Project: WEBSTER ISB PHASE 1

Drawing: LEVEL 0 FND PLAN & PIER/CAP SCHEDULE

Subject: 31 6329 Drilled Concrete Piers and Shafts – Steel Reinforcing Shop Drawings

SHOP DRAWING / SUBMITTAL REVIEW

LEVEL 0 FOUNDATION PLAN

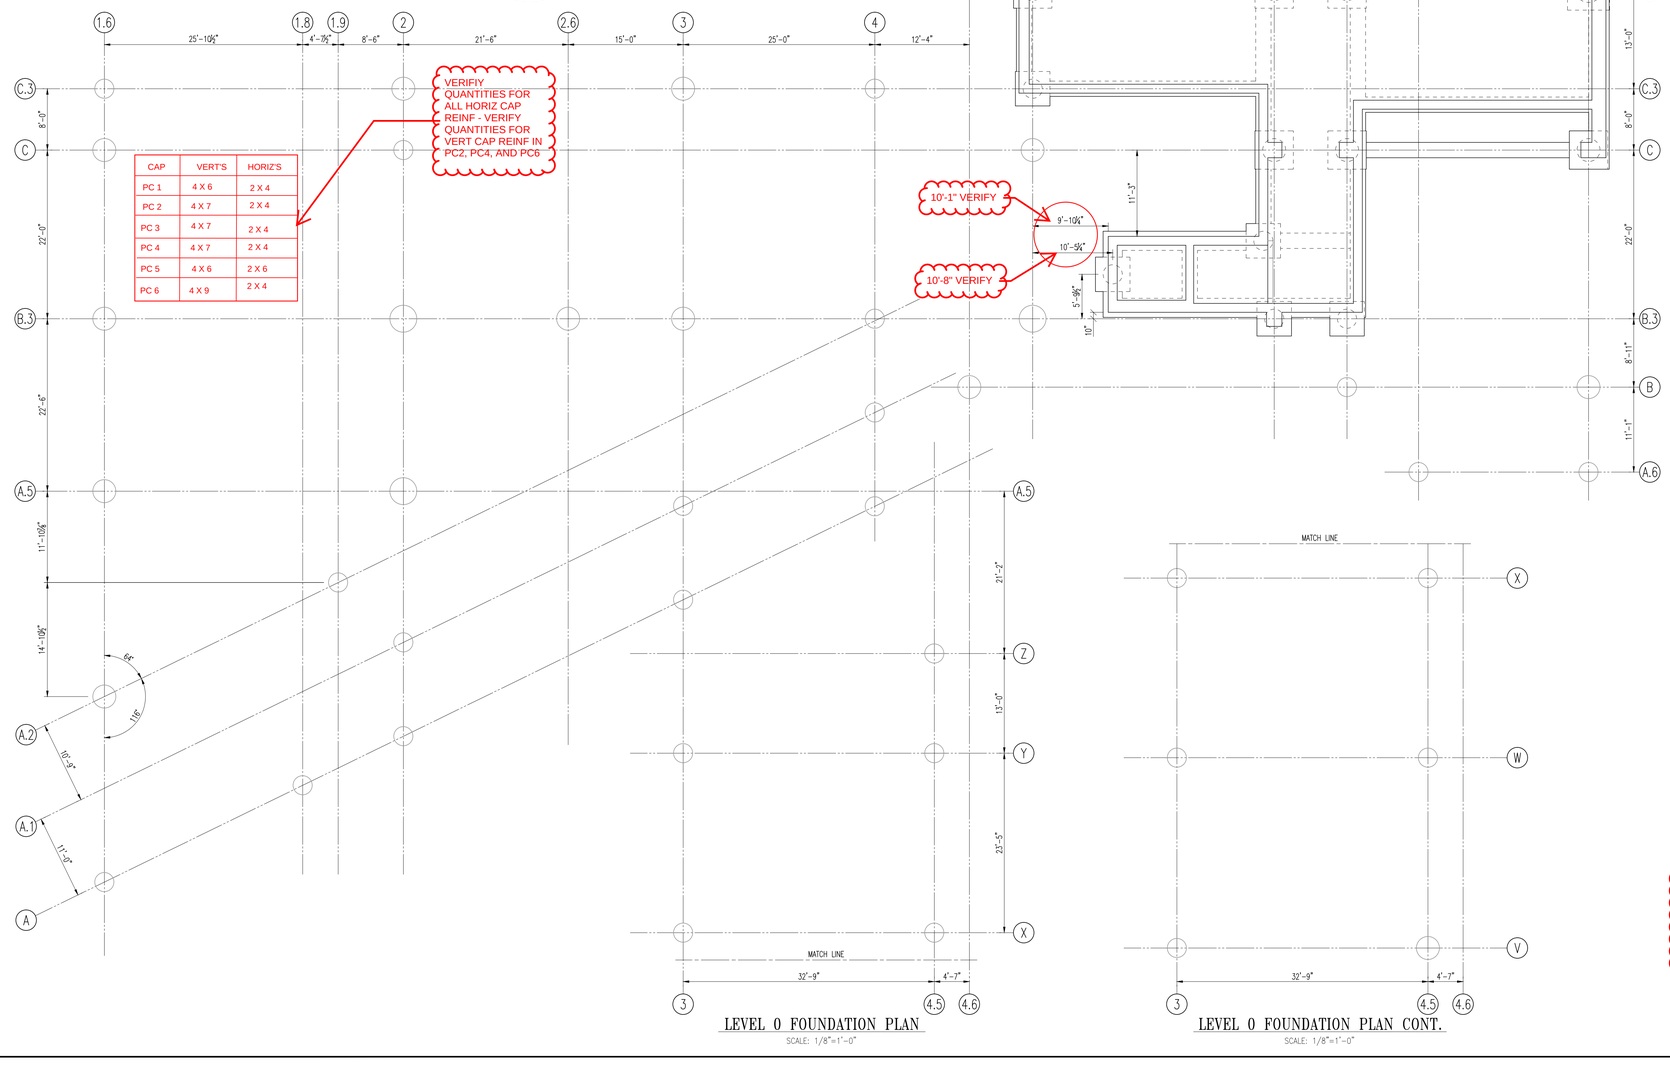
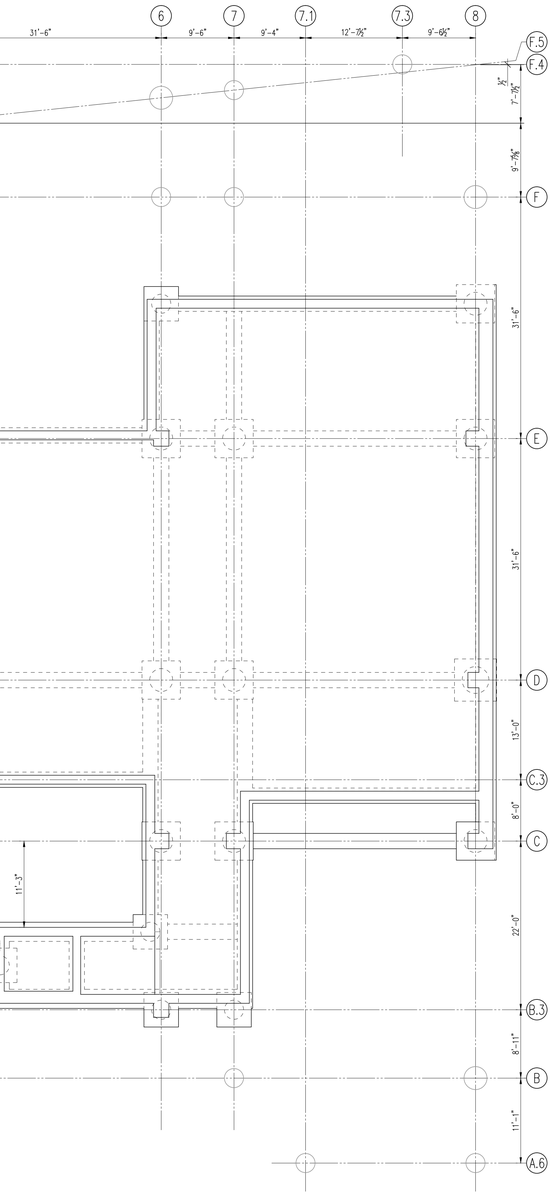
VERIFY LENGTHS WITH 3" CLEAR ON TERMINATORS AND TIE QUANTITIES WHRE NOTED

515'-0" PER S0004 VERIFY

VERIFY QUANTITIES FOR ALL HORIZ CAP REINF - VERIFY QUANTITIES FOR VERT CAP REINF IN PC2, PC4, AND PC6

TYP DRILLED PIER SECTION

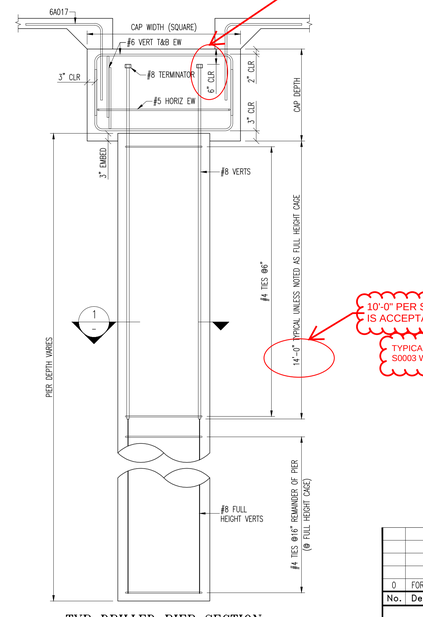
3" PER S0003

10'-0" PER S0004 IS ACCEPTABLE

HOOPS SHALL HAVE SEISMIC HOOKS AT EACH END (3" - 90 DEG) WITH A 6" MIN LAP - EACH ENGAGING A VERTICAL BAR

TYPICAL DETAIL ON S0003 WILL BE UPDATED

TYPICAL DETAIL ON S0003 WILL BE UPDATED

LEVEL 1 FOUNDATION PLAN

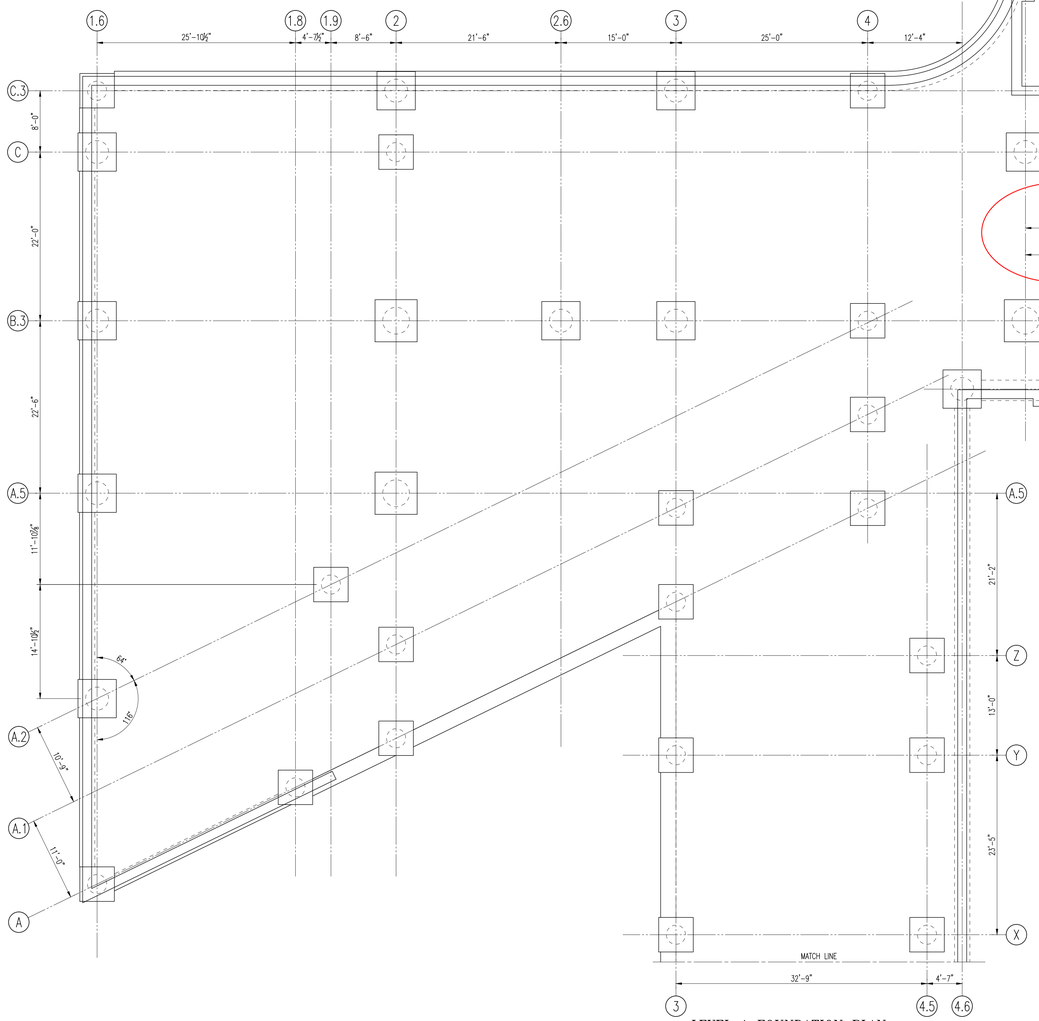
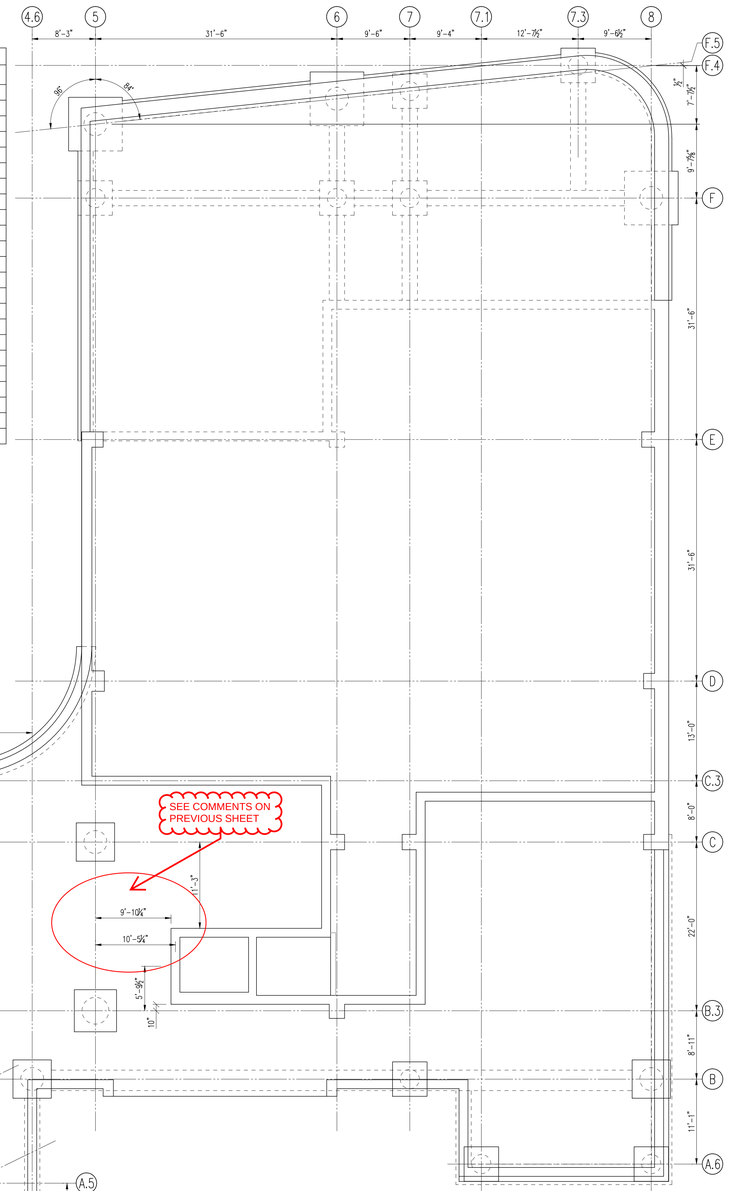
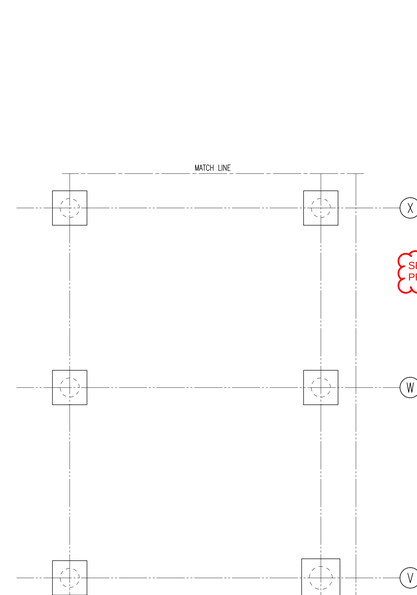
VERIFIY QUANTITIES FOR ALL HORIZ CAP REINF - VERIFY QUANTITIES FOR VERT CAP REINF IN PC2, PC4, AND PC6

VERIFY LENGTHS WITH 3" CLEAR ON TERMINATORS AND REDUCED CAGE DEPTH (WHERE NOT REQUIRED TO BE FULL DEPTH)
